Dartbrook Mine MOD 7 Application
Kayuga Bord and Pillar Mining Operations Mining Review
Prepared for Independent Planning Commission Submission

Report prepared April 2019

This report has been prepared for submission to the Independent Planning Commission. It addresses key mining related issues for this project following review of the proponent's MOD7 EA, Response to Submissions (RTS), the Department of Planning Dartbrook Mod 7 Assessment Report, and associated, publicly available documents.

Figure 2: Bord and Pillar Panels Mining Section Raw Ash

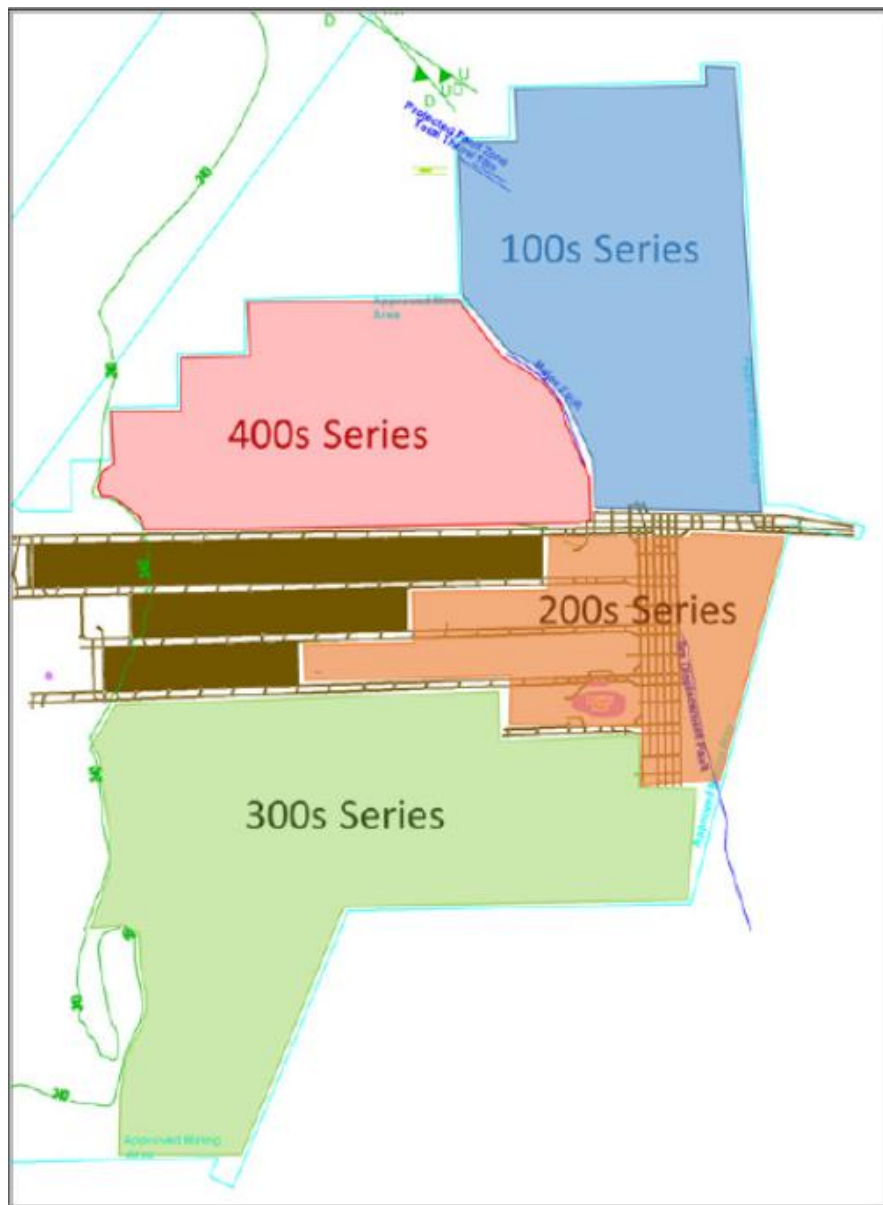
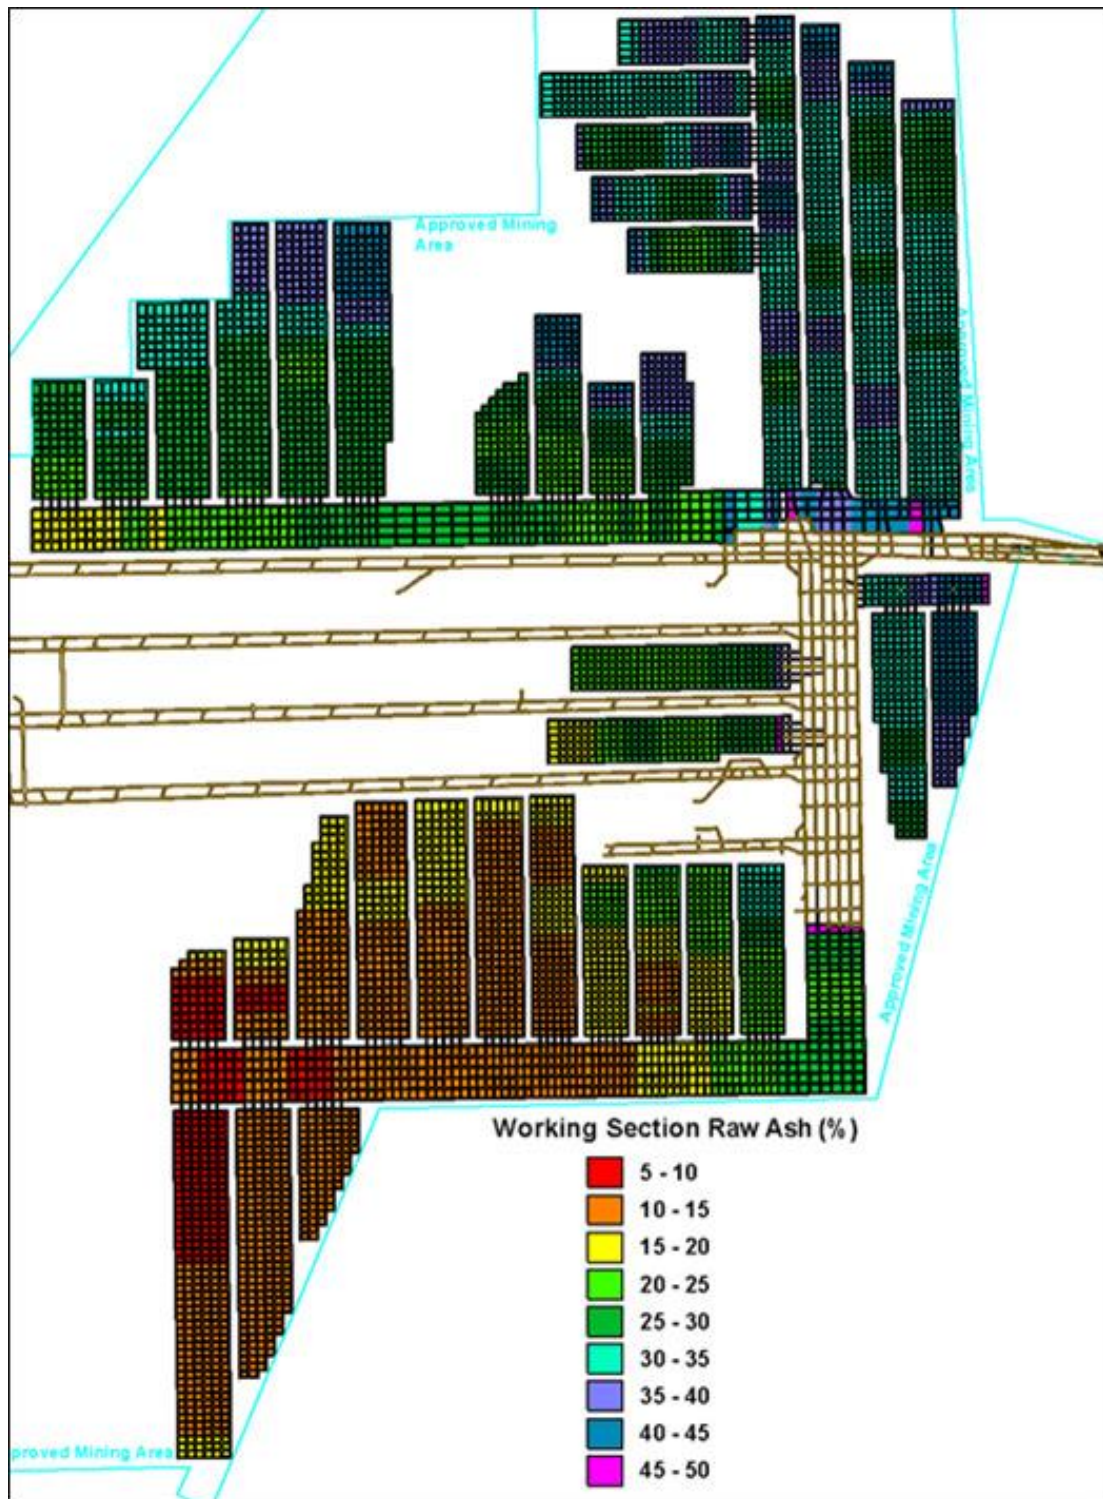
A review of the working section ash as shown in Figure 2 above, shows each of the Mining areas have different working section ash levels.

Figure 1. Mining Section Thickness for Bord and Pillar Panels

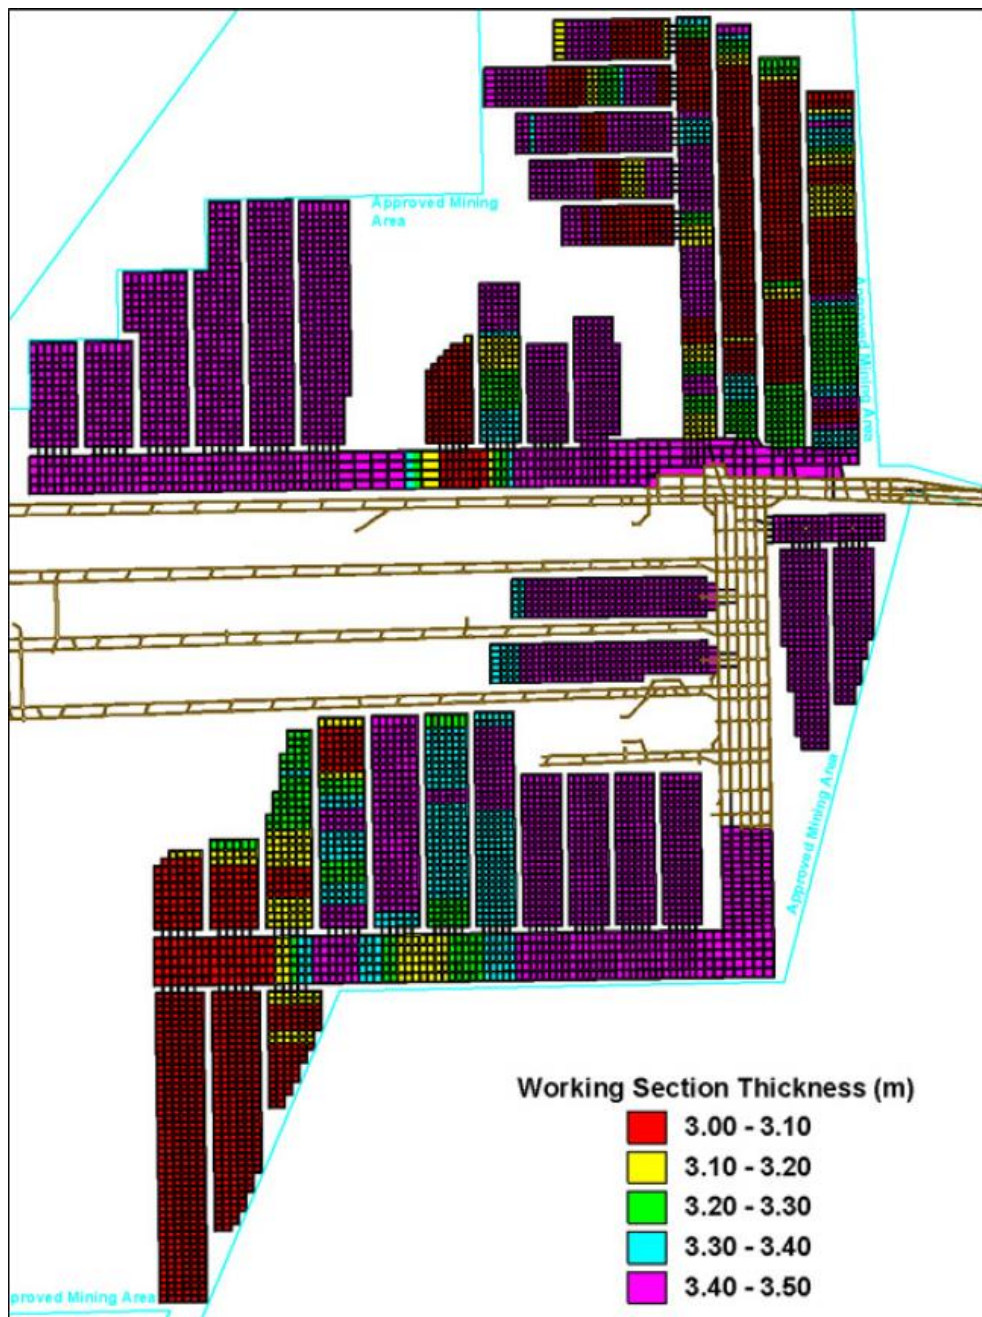
From the geotechnical assessment of the Kayuga Seam it was recommended to leave 300mm of coal in the floor to provide a stable floor for mining operations. The mining height selection for the Kayuga Seam was selected as 3m to 3.5m based on typical practical limitations on Bolter Miners, and to achieve the optimal selection of reserve recovery, productivity and roof dilution where the select seam horizon is less than 3.3m in thickness.

Based on the available geological data and modelling the working section thickness would vary as shown in Figure 1.

Figure 3. Bord and Pillar Panels Mining Section Raw Ash

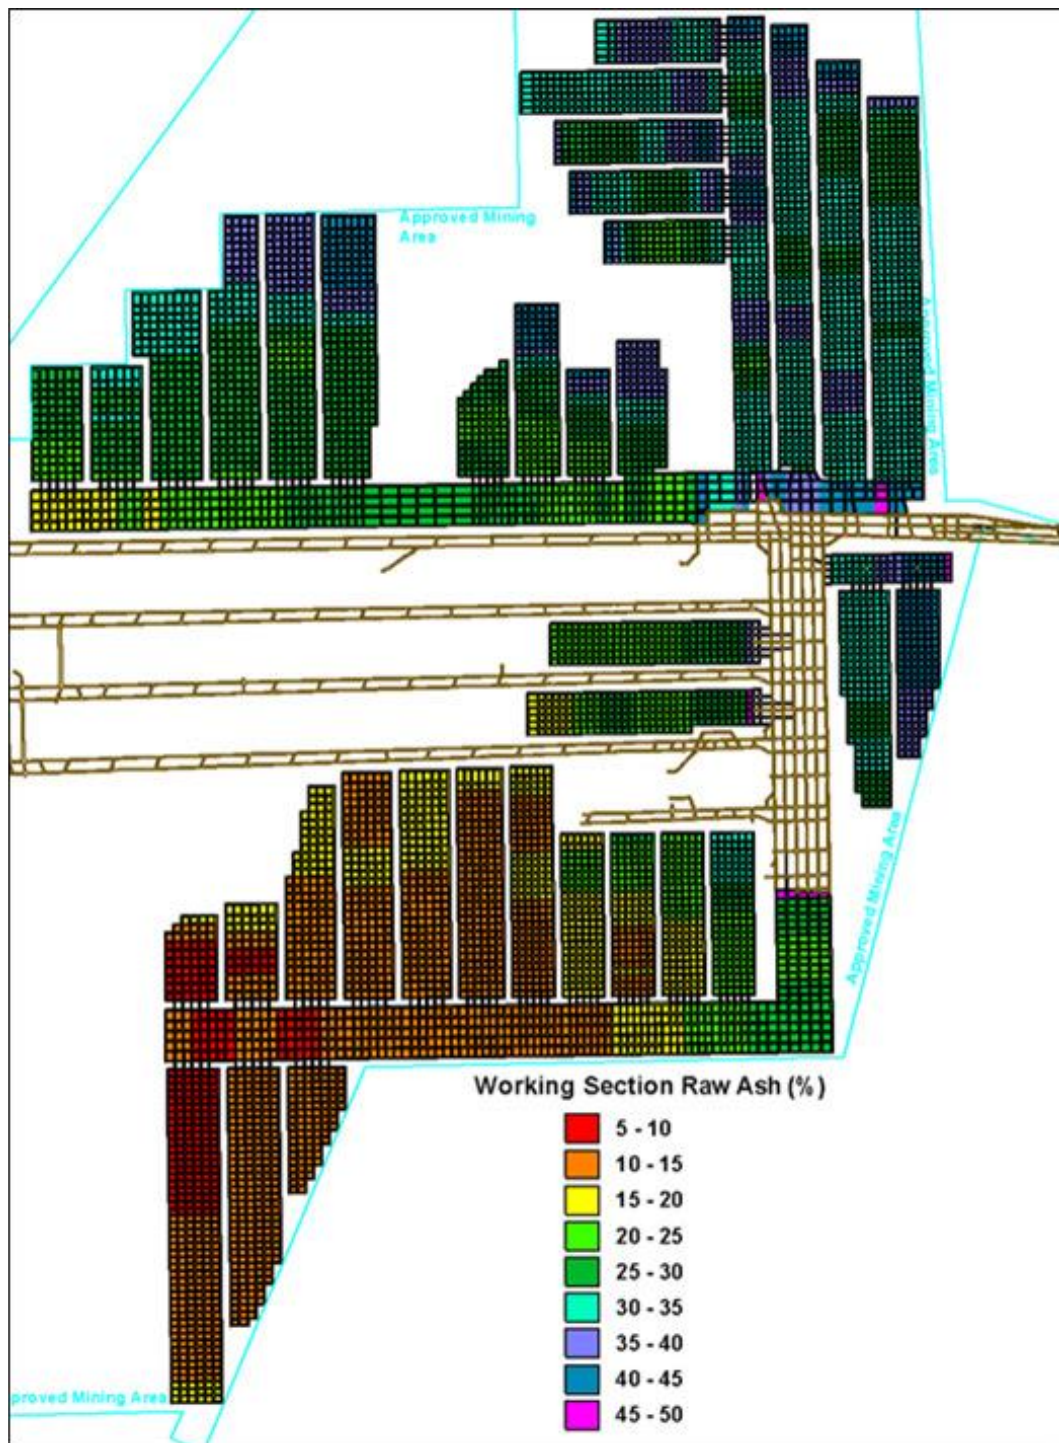
Additionally, by reviewing the working section ash as shown in Figure 3 above, it shows each of the Mining areas have different working section ash levels:

Figure 2: Price differential, 5,500 (high ash) vs 6,000 (benchmark)

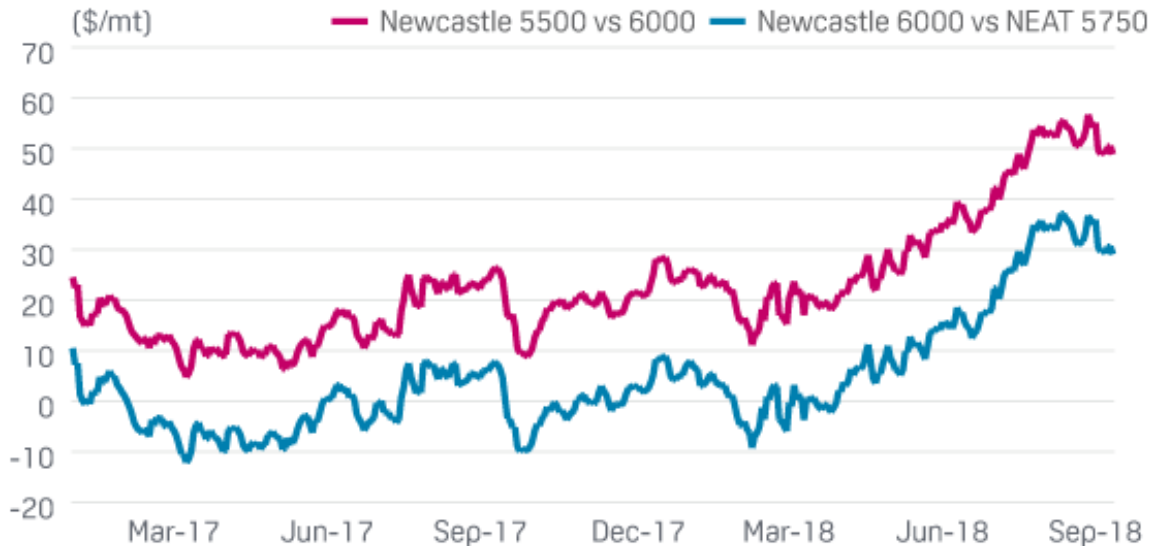
Marsden Jacob’s review finds that the assumed coal price is too high from both price outlook and price discounting perspectives. The World Bank recently forecast that the price of benchmark thermal coal from Australia (see Figure 1) will fall over the coming decade from a peak of \$100 per tonne to \$50 per tonne by 2030, and S&P Global Platts (see Figure 2) identifies that coal of a similar quality that which is proposed to be mine at Dartbrook is trading for a discount of between \$20 and \$50 per tonne.

While it is not possible to accurately estimate how great the differential will be in the future, conservatively applying a 20% price differential (at the lower end of the historic differential) would result in an average forward price of USD\$65 per tonne, over 10% below the coal price in the economic analysis (USD\$73 per tonne).

Figure 4: Economic analysis, National

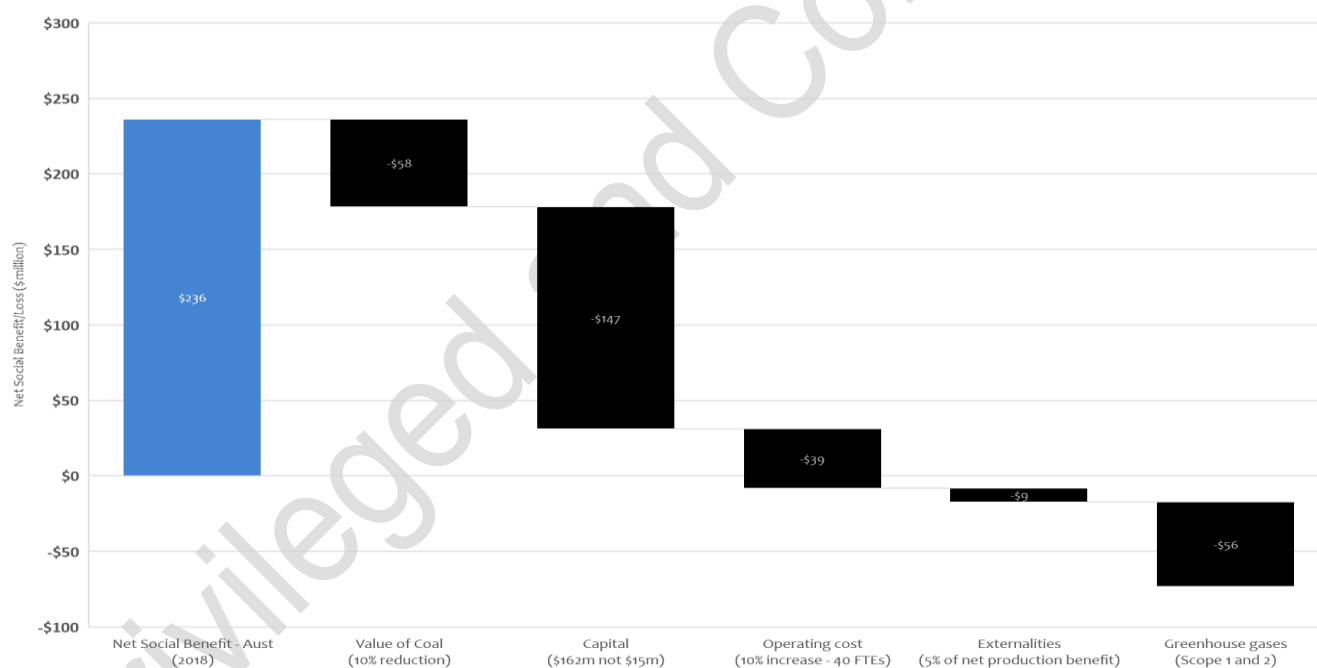
At the National scale the net result is negative \$73 million (see Table 3 and Figure 4), when the changes discussed earlier in this review are made to the assumptions.

Figure 5: Economic analysis, NSW with central assumptions

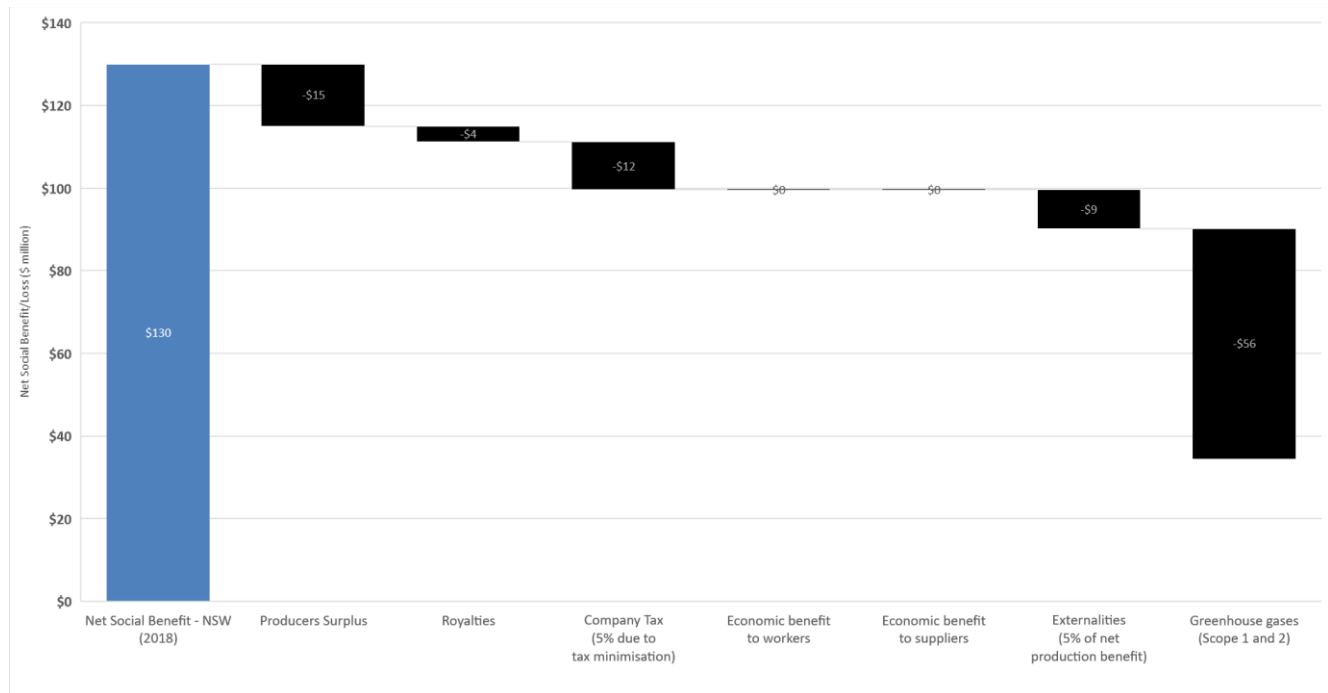
At the NSW scale the net result is marginal, when compared to the central assumptions (see Figure 5), whereas when the result is compared to the worst-case revenue scenario the result is negative \$15 million (see Figure 5). This illustrates how sensitive the outcome is to changes in key assumptions a point that was missed in the Department's assessment (see Table 4).

Figure 2 Upper Hunter Shire, mapping of the 'mine subsidence district'. (Source: Upper Hunter Shire online mapping tools, accessed 20 July 2018, <https://maps.upperhunter.nsw.gov.au/connect/analyst/mobile/#/main?mapcfg=Public%20-%20General>)

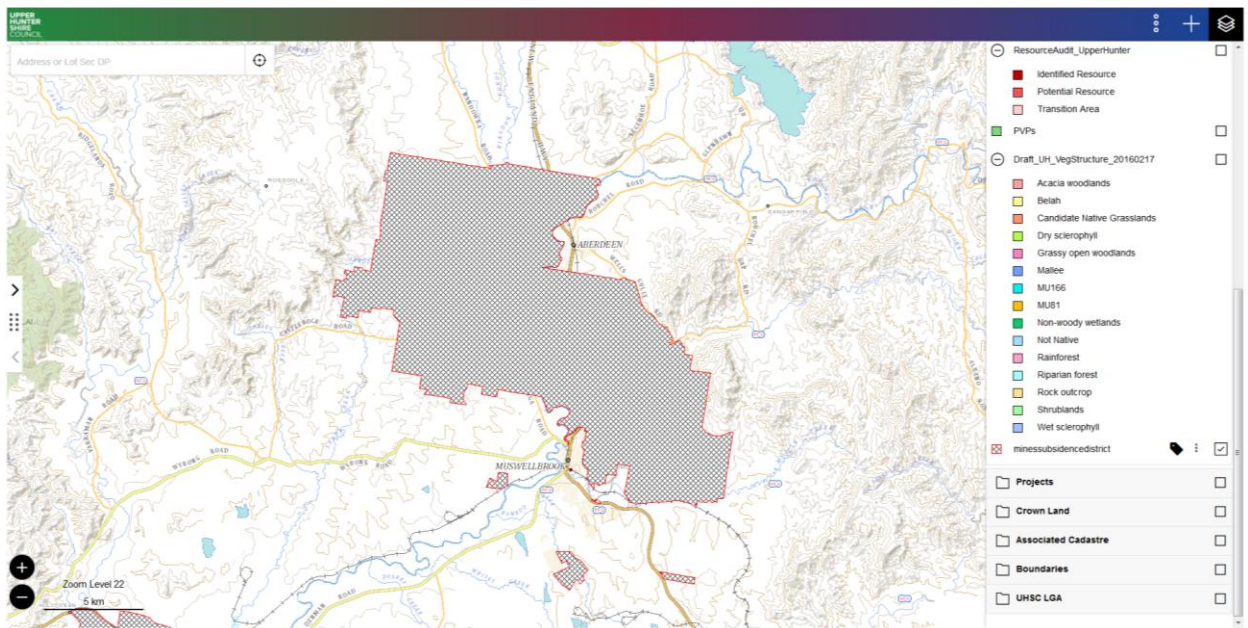
Subsidence impacts may be considerably wider and affect heritage places in surrounding areas. The Upper Hunter Shire has provided mapping for the local subsidence zone (Figure 2). Hansen Bailey (2018: 79) states that "Previous longwall mining in the Wynn Seam has resulted in subsidence of up to 1.6 m and is expected to have caused variable stress conditions and voids within the strata", and "subsidence due to elastic strata compression is typically less than 100 mm" (2018:80), and "If vertical loads result in pillar failure, higher levels of subsidence (typically 0.5-1.5 m) would be expected to occur." (2018:80). In summary it was concluded that "By adopting the nominal factor of safety of 2.11, the pillars can be designed such that pillar failure does not occur. As a result, subsidence can be maintained at the low levels associated with elastic strata compression subsidence" (2018:80).

The assumption made in the assessment documents is that direct impacts to the ground surface, resultant from Modification 7, can be assumed to be 'less than' 100mm across the 'Mining Authority Boundary' (Figure 1). This is not supported by the proponent's self-reported extent of subsidence, nor that impacts across the 'Northern Area', are yet to be understood and need to be assessed with extensive further geotechnical work being required.

Environmental Assessment Report Mod 7 (AQC) - June 2018

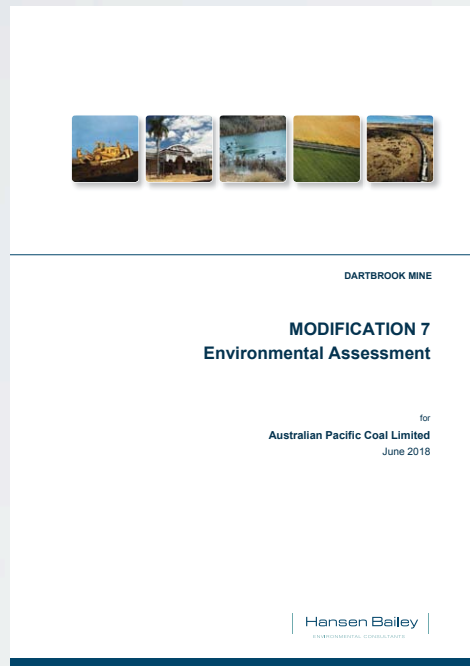
- One (1) paragraph on visual impact assessment plus 2 photos
- “No private residences in the vicinity”
- “The New England Highway is the only public area affected”
- “Visual effect low”
- No mention of 192 B-Double truck movements every 3.5 minutes for 11 hours, or the impacts at the Kayuga Entry or coal handling facility at East Site

Response to Submission Report (AQC) - August 2018

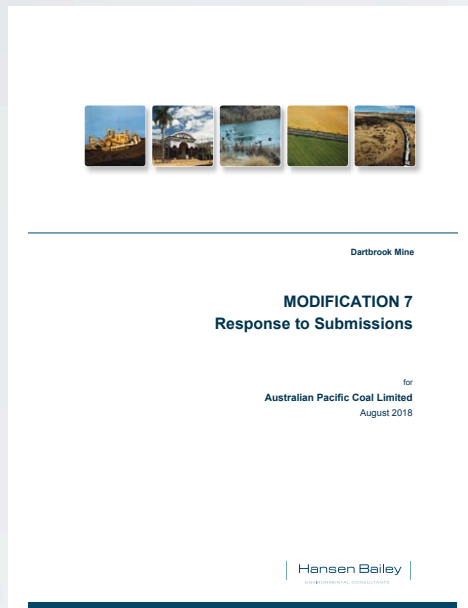
- 2 pages on visual impact assessment plus 1 map
- Focuses on shaft shed with inadequate assessment of truck movements, stockpiles and other facilities
- Private houses not properly assessed - only 1 house identified as being impacted
- Incorrectly states that other houses are screened by topography or vegetation
- Local roads or streets were not assessed

Assessment Report (DPE) - January 2019

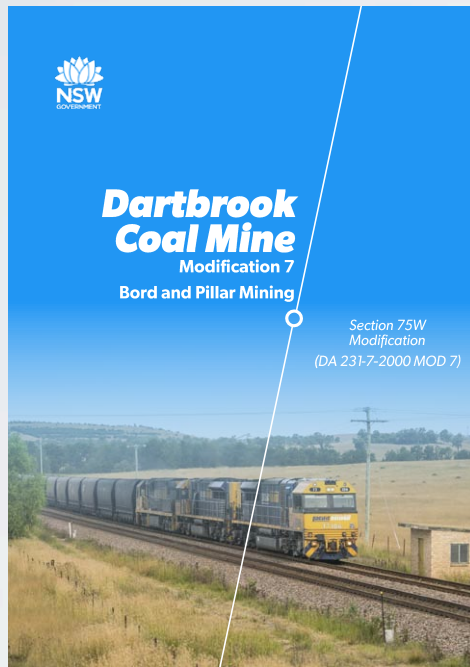
- Visual impacts are not mentioned in the report
- “Social impacts actually experienced would be more akin to a new mine”
